Development Application Assessment Form

Development Application No.	2020/446
Property Description	Lot: 20 DP: 1250165, 28 Mosman Chase LENNOX HEAD
Proposed Development	Construction of a two storey dwelling and associated earthworks and retaining walls as depicted in plans by Eco-Essence Homes, Project No. 1749 insert plan details
Building Classification	1(a) & 110(a)
Site Inspection Date	23/07/2020

② SPLIT SECTION (COMPLIANT TO SINGLE LEVEL + 1m ABOVE NGL)

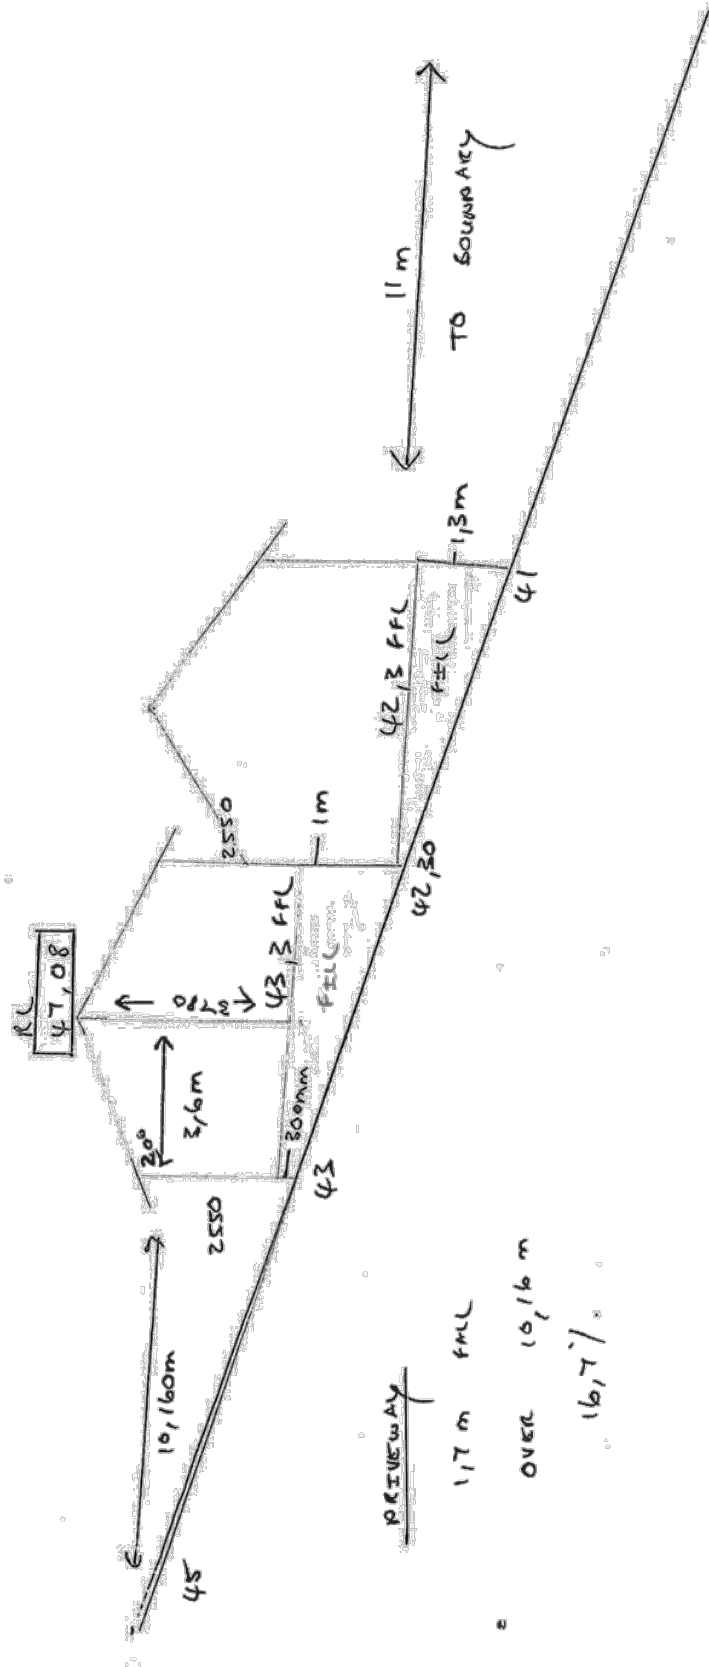
I am sure there are numerous ways to change the design to give everyone a good outcome for example lowering the floor level, changing the roof pitch, changing the roof design, increase the setback or doing a whole redesign to a split level.

A reasonable compromise would be to allow the double storey design, but to lower the building height, this will allow for view sharing with neighbours to the North, whereby the view loss would be more acceptable, also satisfying the BLEP 2012 and view sharing principles.

Lot 9 DP1250165 No 19 Mosman Chase, Lennox Head – (DA2019/333)

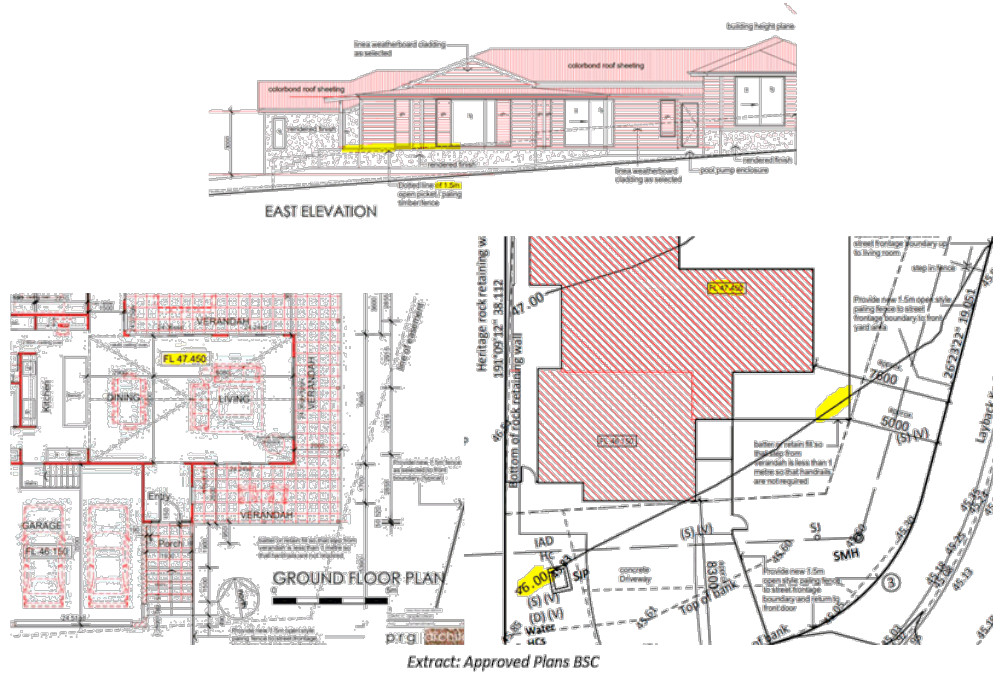
The primary objector is the landowner of No. 19 Mosman Chase. The dwelling upon this site was approved in accordance with DA2019/333. A brief examination of this development consent and approved plans has revealed this dwelling is contrary to, and not compliant with, the nominated 88B covenant that forms the basis of this adjoining owner's objection. The applicable covenant restricts the floor level of the single storey dwelling to no more than 1m above natural ground level. Below is the eastern elevation of the approved plan set. The portion of the dwelling in the south east corner of the subject site has a FFL of 47.45m. The natural ground level immediately below this section of the approved dwelling is AHD 46m. The approved dwelling, primarily the verandah and living areas is greater than 1m above natural ground level and contrary to the covenant in the south eastern corner of the site. This is confirmed by the below elevation indicating a 1.5m high, side boundary fence will be

Lot 17 DP1250165 30 Mosman Chase – (DA2019/72)

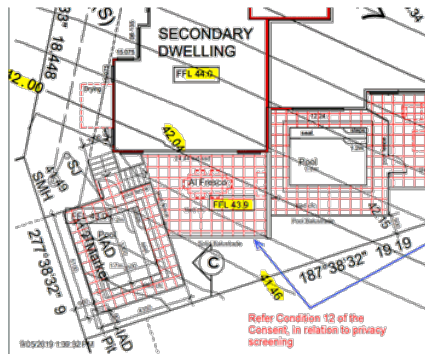
This lot is subject to the 88B restriction on title imposed by the land developer, restricting floor levels to no greater than 1m above NGL. This site is the subject of Council approved development consent DA2019/72. This approval includes a single dwelling with pool and attached secondary dwelling. The secondary dwelling is located in the south eastern corner of the subject site. This small dwelling has a FFL of 44m AHD. The natural ground level immediately below this secondary dwelling living area is approximately AHD 42m. As with No. 19 Mosman Chase, this development consent is contrary to this covenant. Again, it is most likely that no consideration was given to the proposed height above natural ground level, given this is not a consideration under Section 4.15 of the Environmental Planning and Assessment Act, being a developer imposed covenant on the title.

Lot 10 DP1250165 17 Mosman Chase – (DA2019/59)

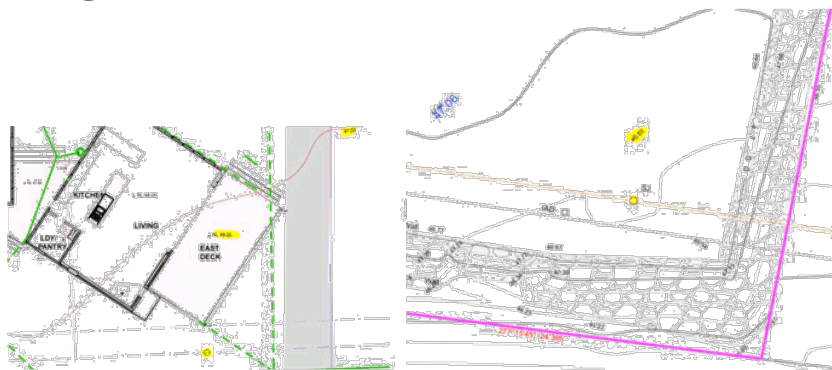
The landowners of this site submitted an objection to the proposed dwelling at No. 28 Mosman Chase. This Lot is also subject to the covenant restricting dwelling floor levels to no more than 1m above natural ground level to benefit dwellings to the north/north west. The approved plans are not clear, however it appears the approved development is not compliant with the 88B restriction in the south eastern corner of the site. The approved FFL of the main living area and eastern deck of this dwelling is RL 48.05m while the survey plans have a NGL of 46.83m directly below the subject eastern deck. Again Council have not closely considered this aspect of the development given the lack of detail on the approved plans. Further, given this restriction is not a relevant planning control that Council is obligated to consider, no condition of consent has been imposed limiting the approved floor level to 1m above natural ground level.
